Engineering changes and advances in the HL-LHC s.c. circuits

[since the last Internal Circuit Review in March 2017]

Felix Rodriguez Mateos for the MCF

TCC – 2nd November 2017

Under study: Insertion of a cold diode across Q1a k-modulation circuit

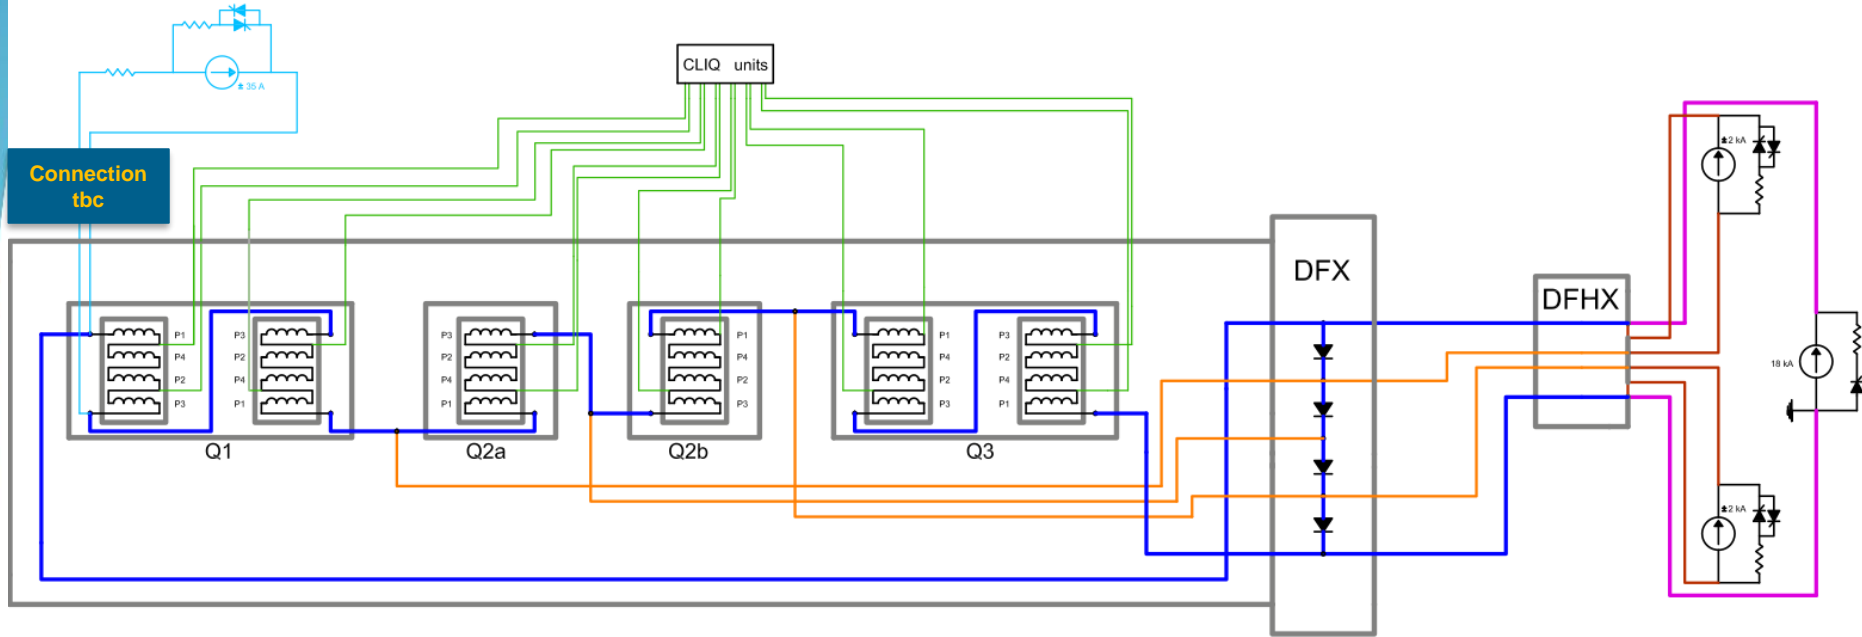
Options to protect bus-bars

Protection baseline: Any quench in any element \rightarrow Fire all the QHs/CLIQ systems

When introducing the cold diodes, two possible strategies:

1. One element quenches \rightarrow All QHs/CLIQ systems will be fired. Diodes carry only the over-currents (7 kA or less) for an equivalent time = 100 ms
2. One element quenches \rightarrow Selective QHs/CLIQ fired. Diodes carry 18 kA, time constant = 100 s

Possible advantage for option2: If a quench of the other magnets following the first cannot be completely avoided, these would happen at lower current, reducing the stress on the magnet and the heat introduced into the cryogenic system, which will allow a faster recovery.

Option 1 – Quench Protection Strategy

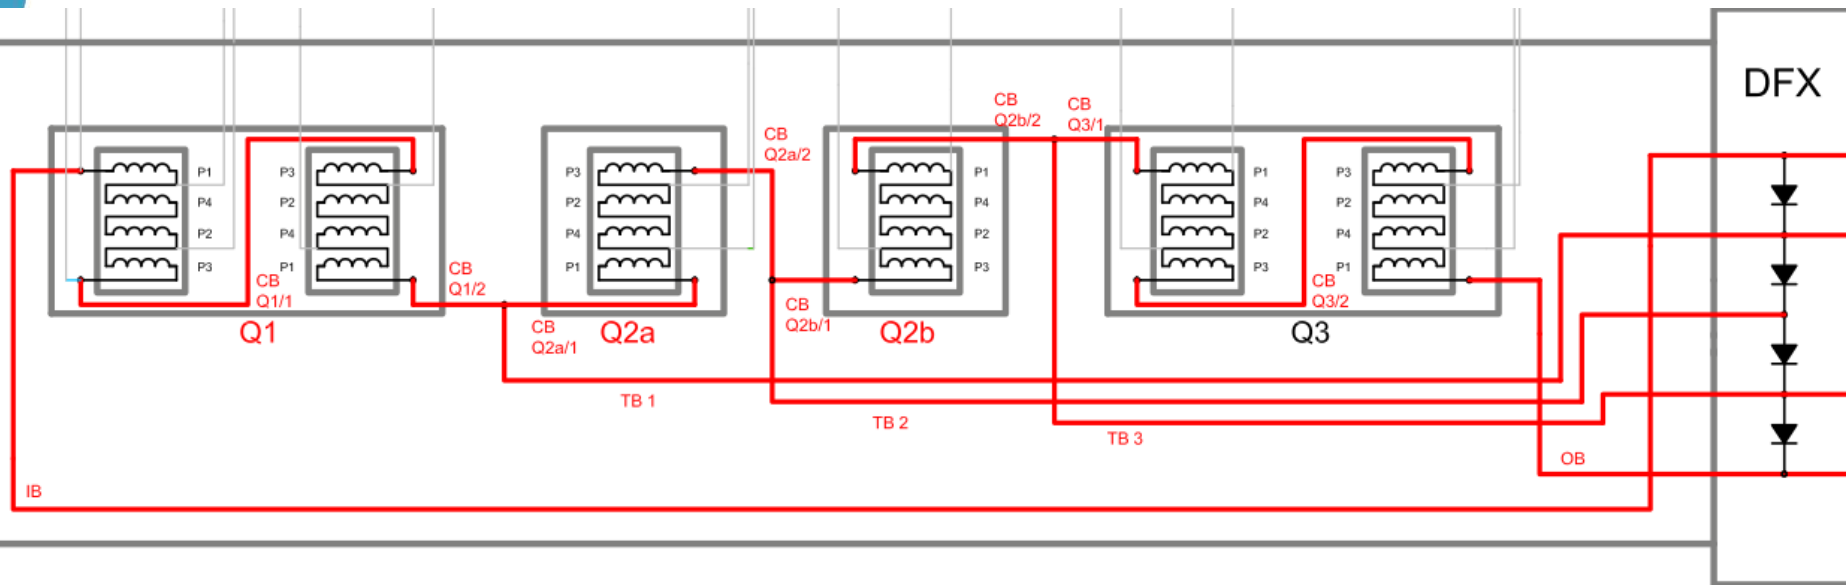
- Any busbar quenching → Firing all protection systems
- Diodes carry only the over-currents (7 kA or less) for time constant or equivalent time = 100 ms

Option 1: One element quenches → All QPS systems will be fired

- Bus-bar integration in the cryostat is less complex
- No need to size the trim bus bars to 18 kA (sc state and quenching state)
- No need to integrate heat sinks for diodes

- Keeps the QDS reliability like in the LHC's IT circuit
- The triplet circuit in itself is the most complex HL-LHC circuit. Option 1 does not add further complexity from the QDS point of view.
- The use of the LHC diodes if qualified for radiation levels.

- When quench, no quick distinction between quench in coil and bus-bars in terms of detection

After discussions, MCF considers option 1 as more adequate

Option 2 – Quench Protection Strategy

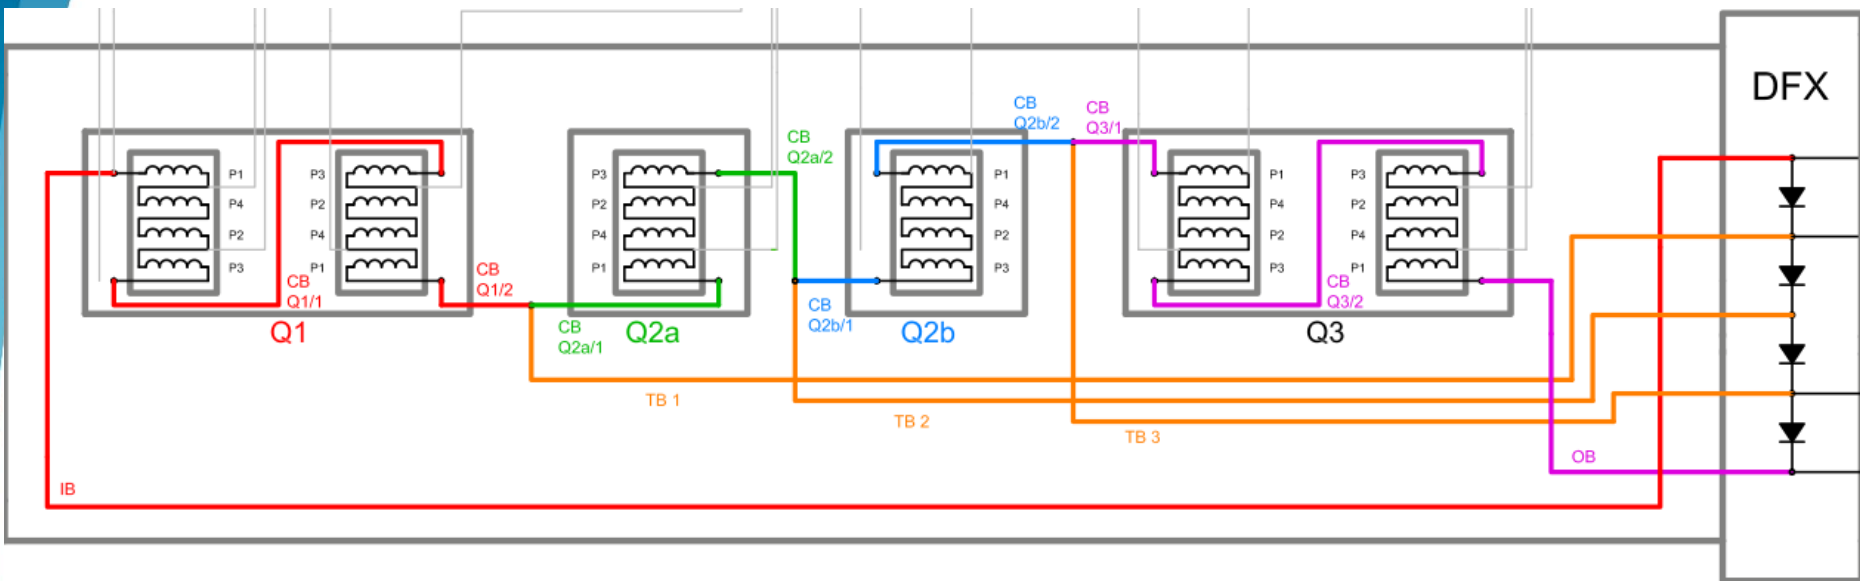
- If any of IB, CB Q1/1 and CB Q1/2 quenches → QPS of Q1 will be triggered
- If any of CB Q2a/1 and CB Q2a/2 quenches → QPS of Q2a will be triggered
- If any of CB Q2b/1 and CB Q2b/2 quenches → QPS of Q2b will be triggered
- If any of OB, CB Q3/1 and CB Q3/2 quenches → QPS of Q3 will be triggered
- If any TB1, TB2 and TB3 quenches → QPS of the two adjacent magnets will be triggered

Possible advantages of the selective quench protection:

- Triggering of the QHs/CLIQ of the other (not initially-quenching) magnets at a lower current (expected ca. 10% less from one magnet to the adjacent one)
- It will allow more energy to be dissipated in the crowbar of the RQX PC

- It includes complexity in the implementation of the QDS which leads to a less reliable system.
- Due to the quench propagation, all the magnets could eventually be fired (in the order of ten seconds between the quench of the different magnets)
- Diodes (+heat sinks) and bus-bars will be significantly bigger
- Imposes new (non-LHC) diodes to support the current of 18 kA

Proposal for Separators for the IT Main Circuit

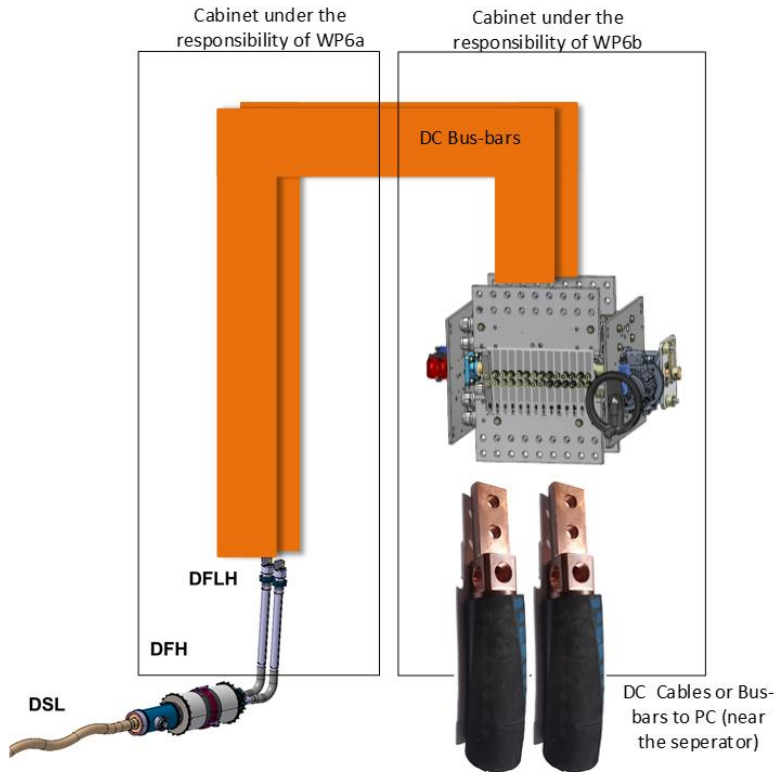
- Number of cabinets is preliminary and needs to be studied in details
- We can have short circuit positions on the three sub-circuits
- Circuit of Q1a not shown for simplification but can have the same principle
- Four separators in total (could be reduced to 3 [2x2 poles + 1x3poles] if short circuit position is not needed)

Proposal for Separators for D1/D2/OCs

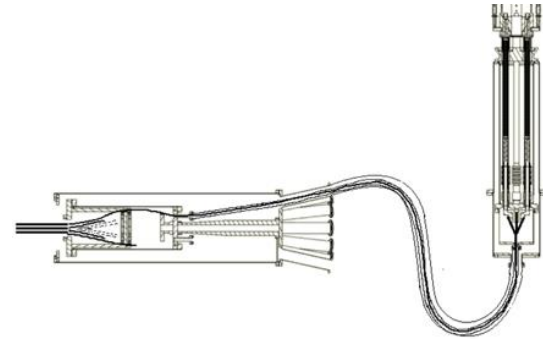
- 13 kA or 2 kA OC separators
- 8 separators
- Can we integrate 2x2 kA separators per cabinet?
- 3 positions: connected, disconnected and short-circuit

DFLH close to PC → distributed leads:
Is this feasible?

120 A LHC currents leads

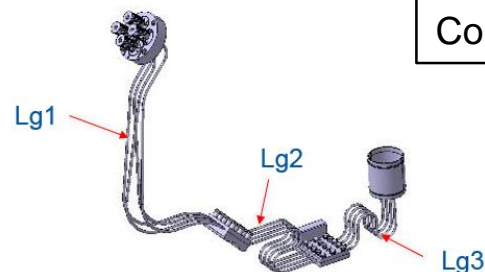
- 1 bloc => 2 circuit with 120 A (4 leads)
- Reserve parts existing.

- ~ Same parts as LHC 120A current lead.
- Change the flange position.
- Add a slit on the thermal screen.

- Final design.
- New bending Tools.

Q4, Q5 and Q6 correctors

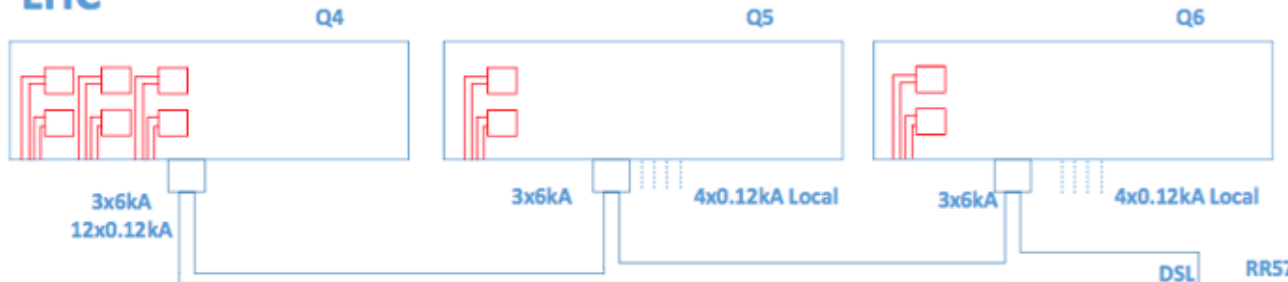
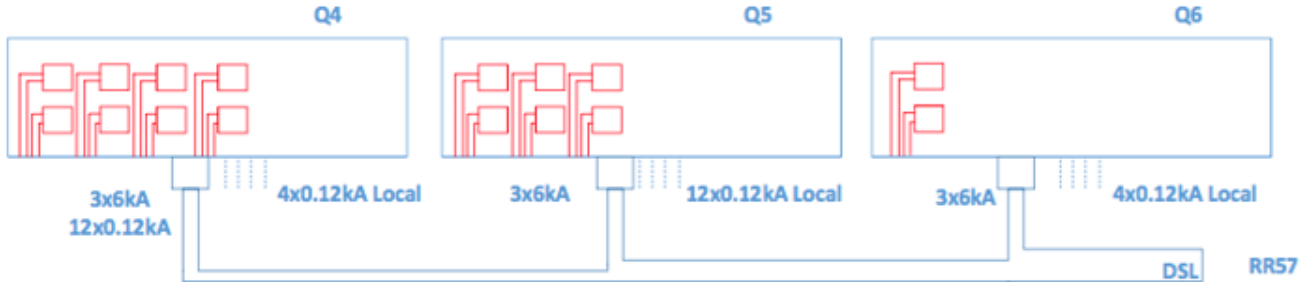
- Local powering for supplementary Q4 correctors
- Local Powering of Q5 correctors
- Q6 as LHC configuration

Scheme of the three-cable configuration

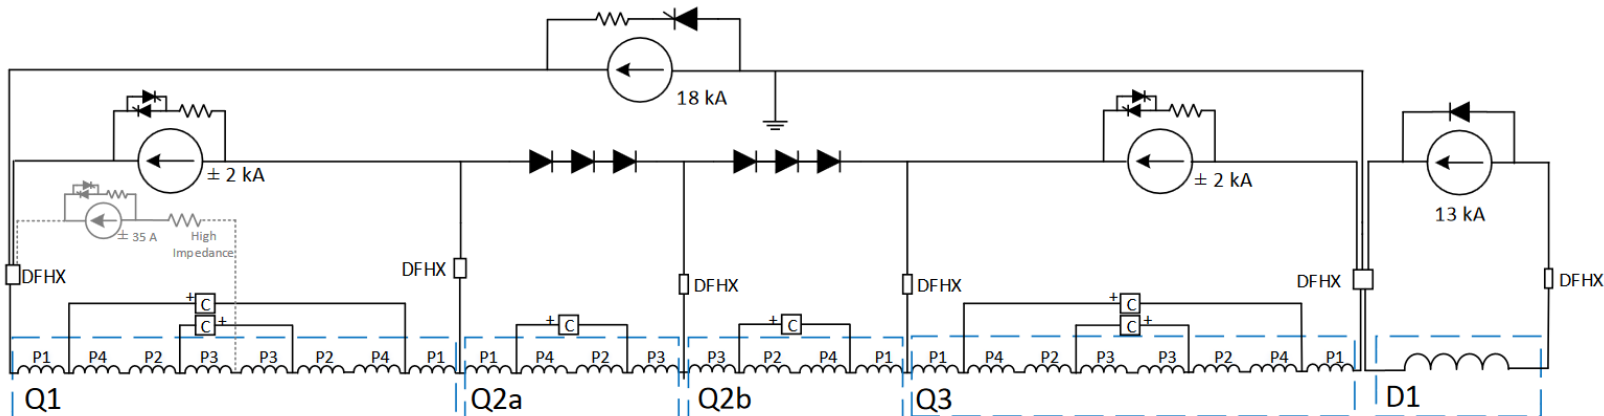
- No clear advantages for WP6b (Transparent to control, same number of power converters, etc.).

- Electrical common point for two different circuits
- Additional complexity in searching for earth faults
- Longer estimated MTTR time for TE-EPC (12 hours + 50 %)
- Electrical issue on D1 circuit impacts IT circuit and vice et versa
- Four cables connection on the current leads (or circuit separator) (2 for 18 kA – 1 for 13 kA and 1 for 2 kA)

Scheme of the three-cable configuration

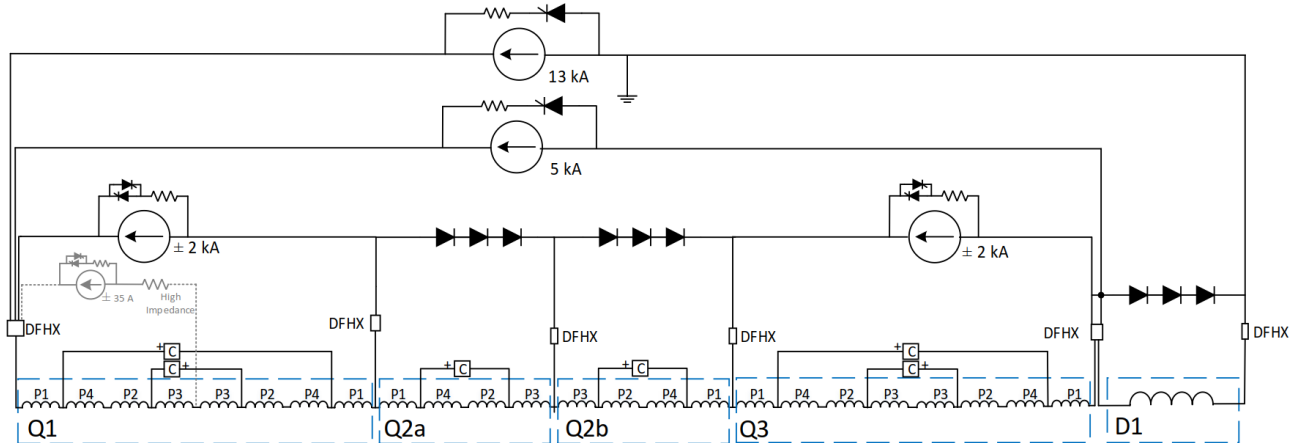
- 1x 18 kA lead less
- 1x spare lead / link

- ELQA to be performed all together (incl. higher voltage withstand requirements of triplet on D1, ...)
- Quench cross talk between triplet and D1
- PC regulation more complicated
- 4th cable at warm
- Commissioning more complicated
- More simulations required to study failure cases etc. (→ manpower)
